ADDENDUM NO. 4

TO: PLANS AND SPECIFICATIONS FOR STATE OF MISSOURI

Renovate Mechanical / Electrical / Life-Safety / State Office Building
Jefferson State Office Building
205 Jefferson Street
Jefferson City, MO 65101
PROJECT NO. O1911-01

SHEET NUMBER:
M3.14
109 OF 244 SHEETS

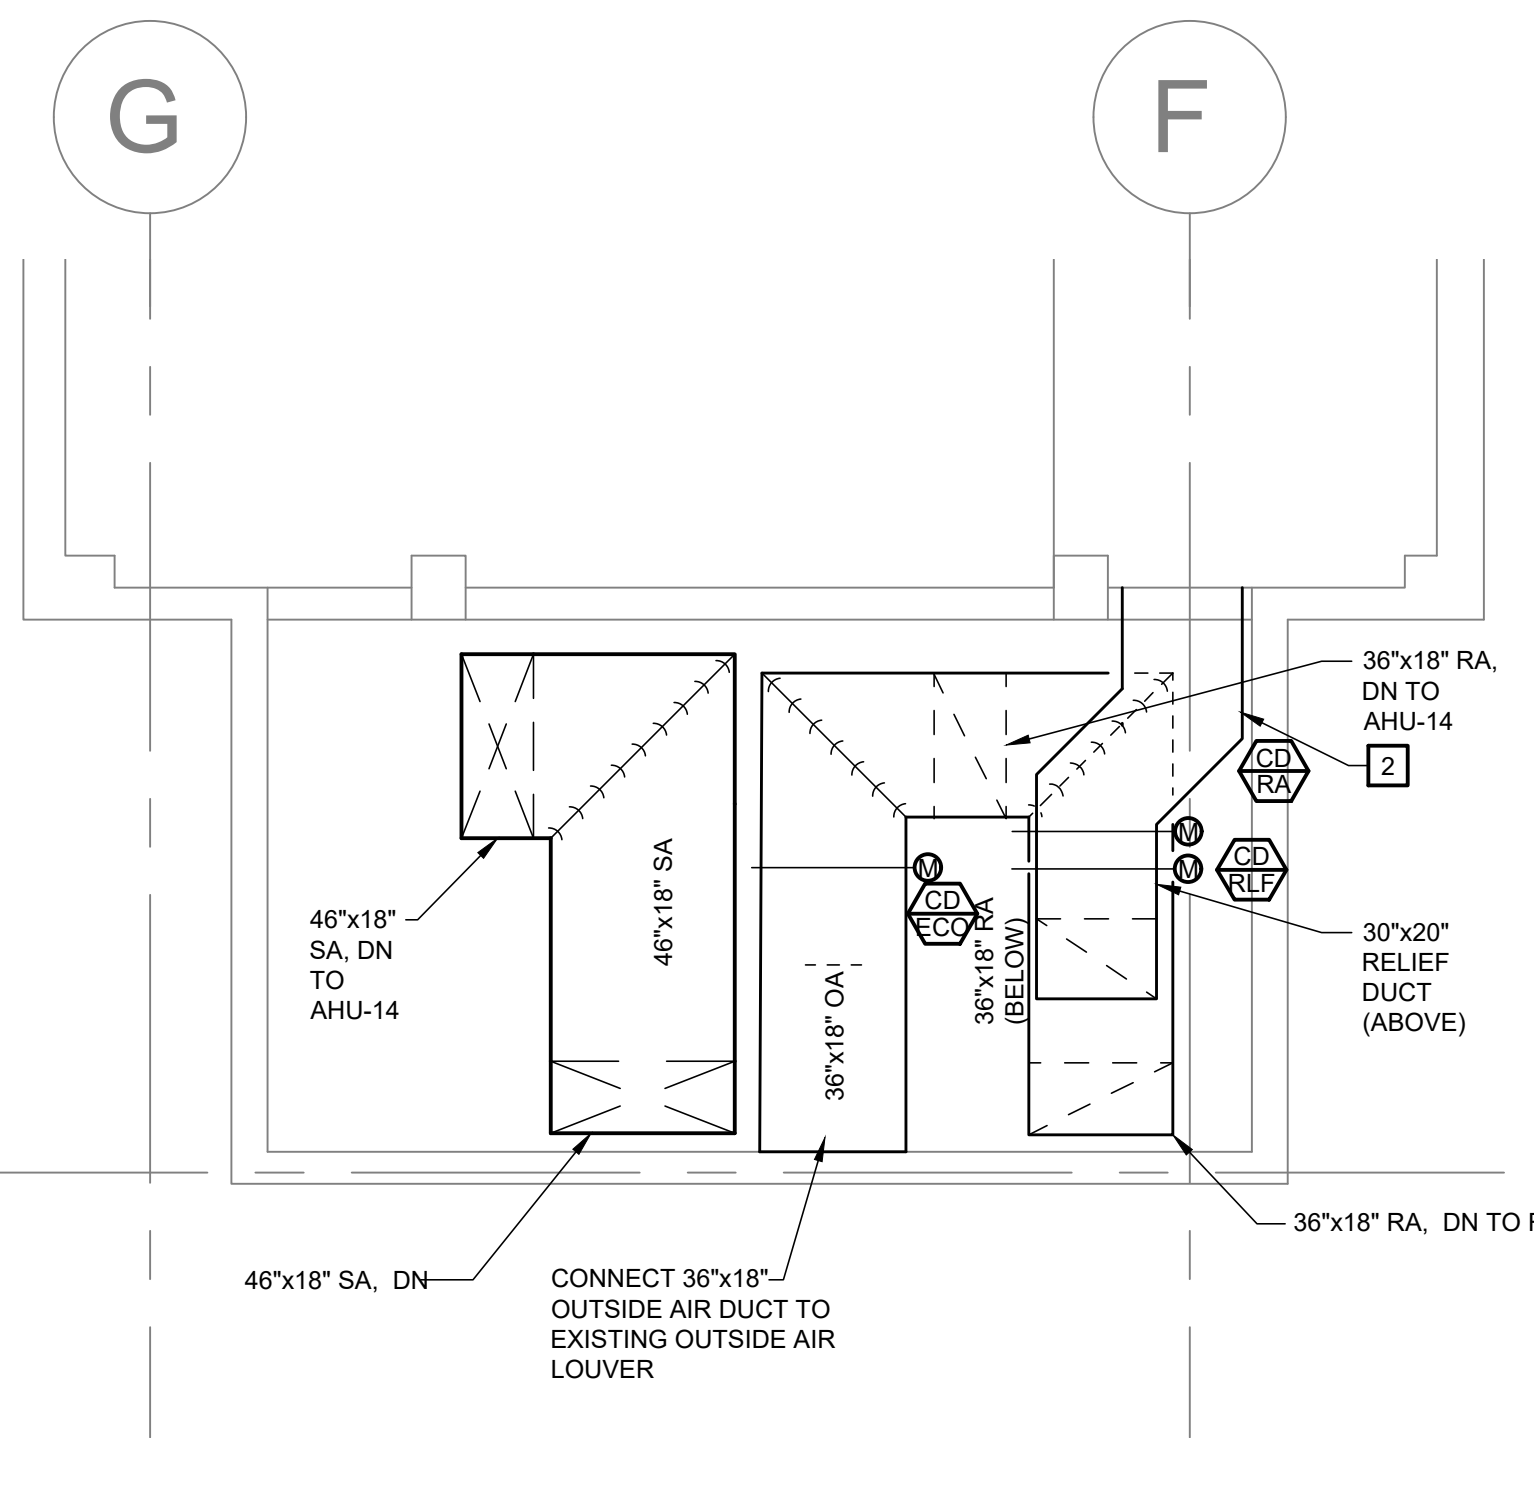
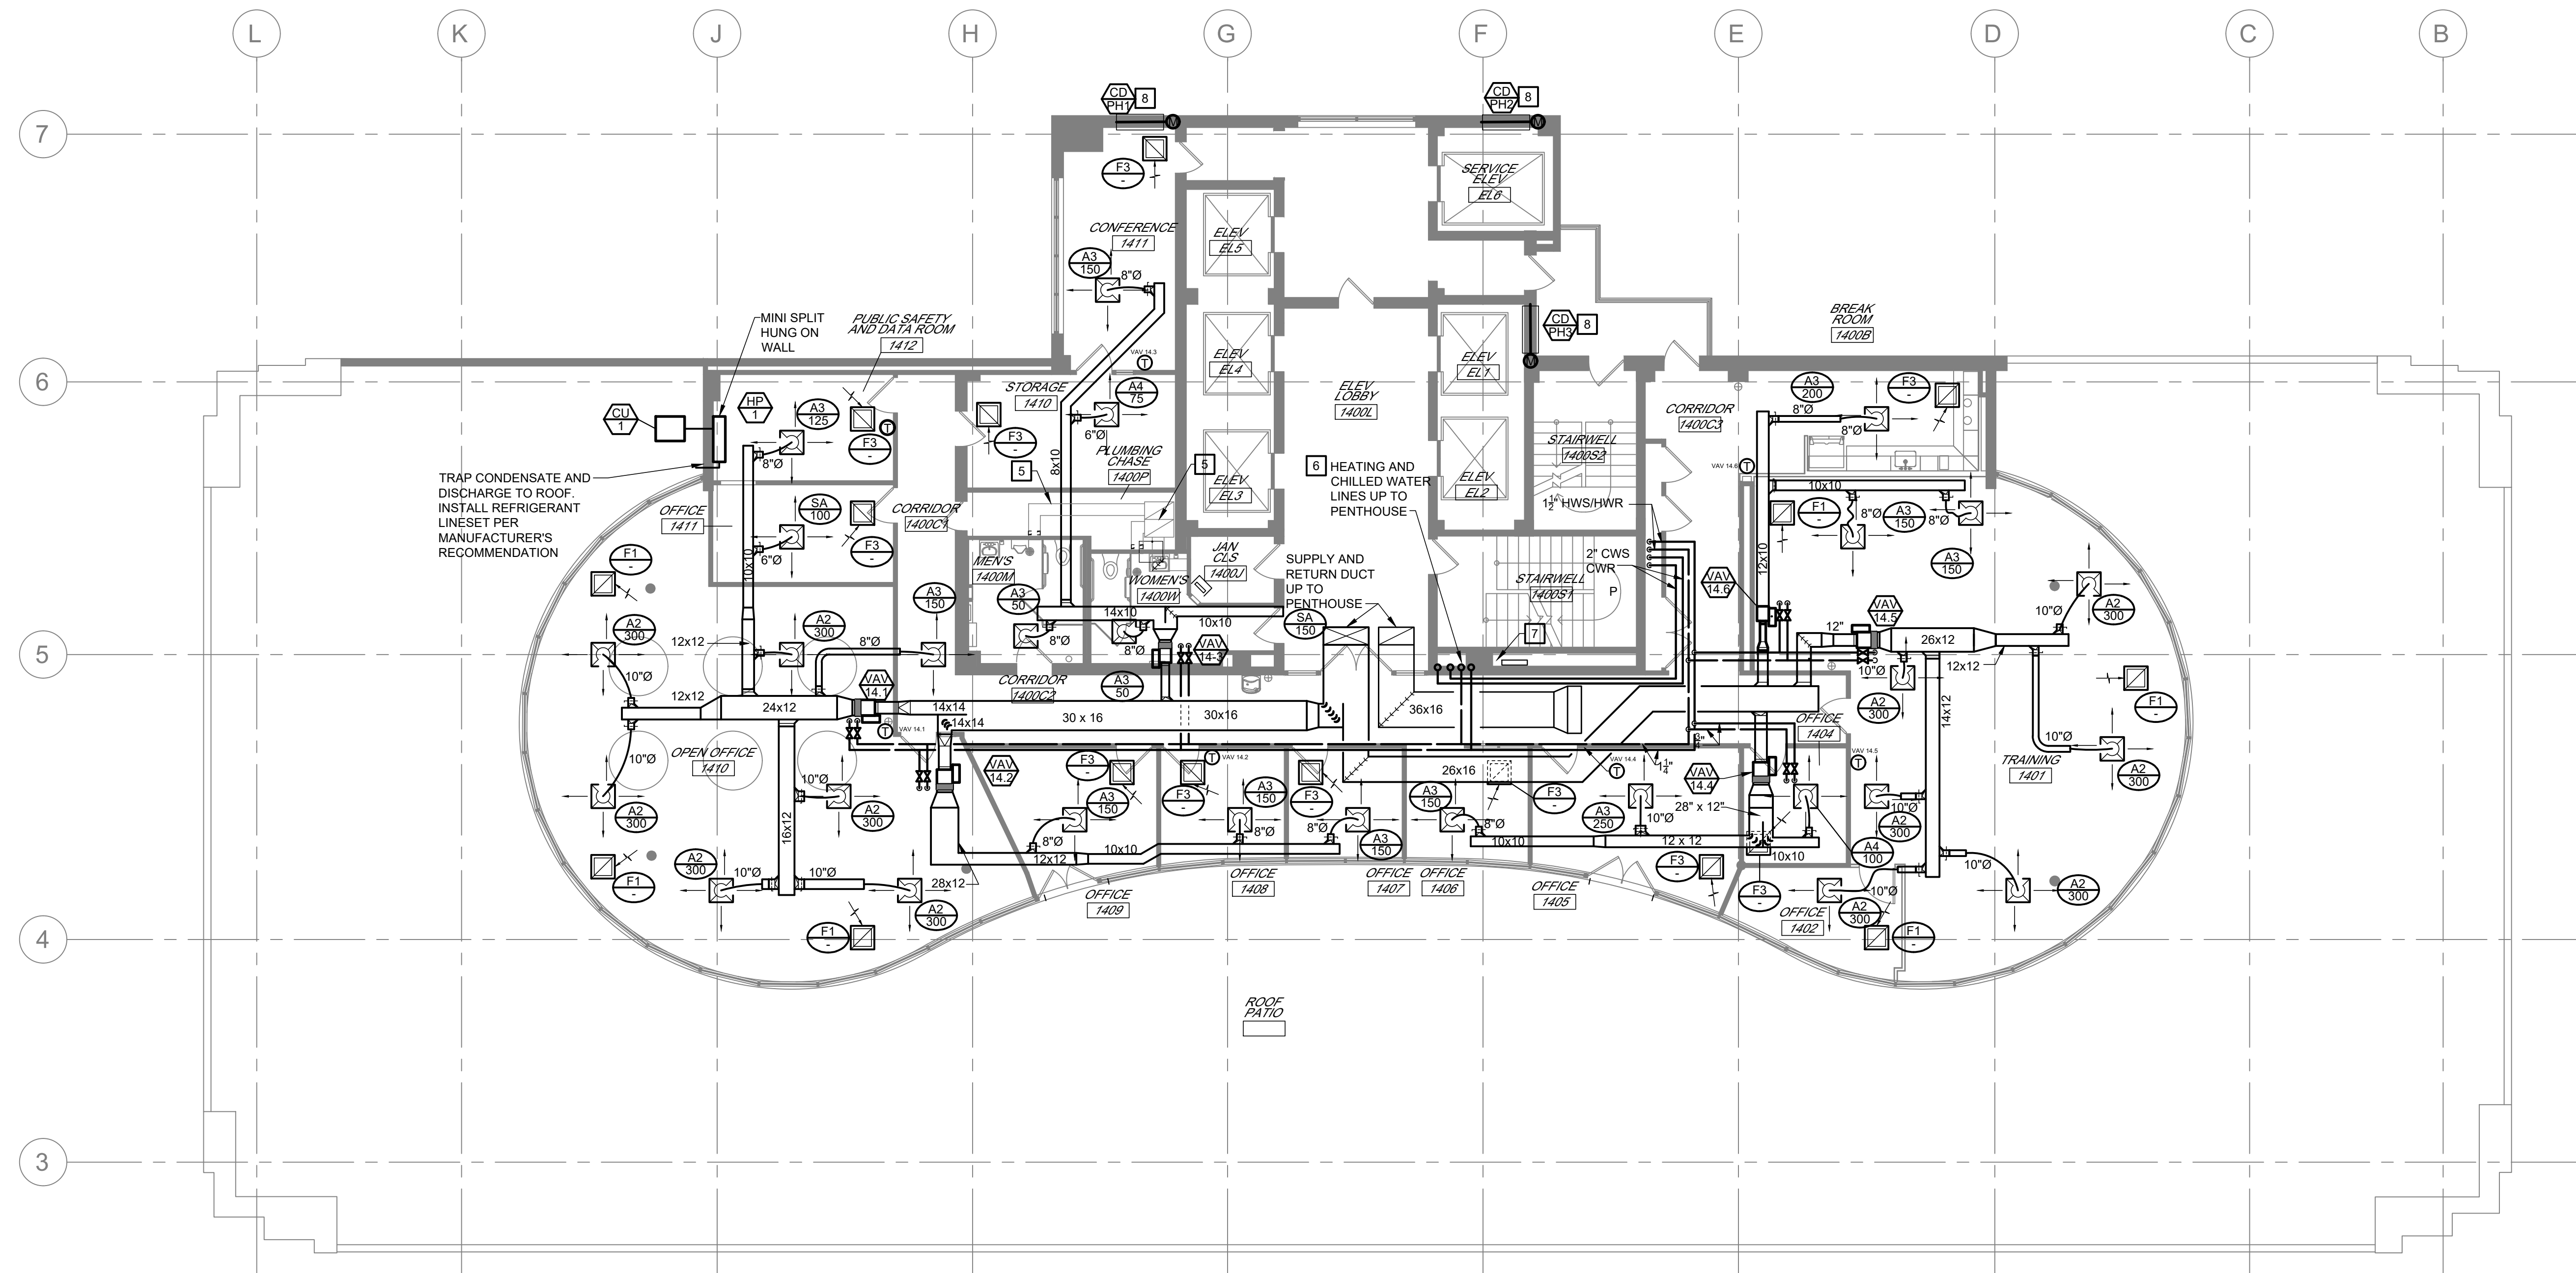
- a. **ADJUSTED**- Pipe Riser Size.
 11. Drawing M3.2:
 - a. **ADDED** – Piping to FCU-C.
 12. Drawing M3.14:
 - a. **ADDED** – House Keeping Pad
 13. Drawing M4.0:
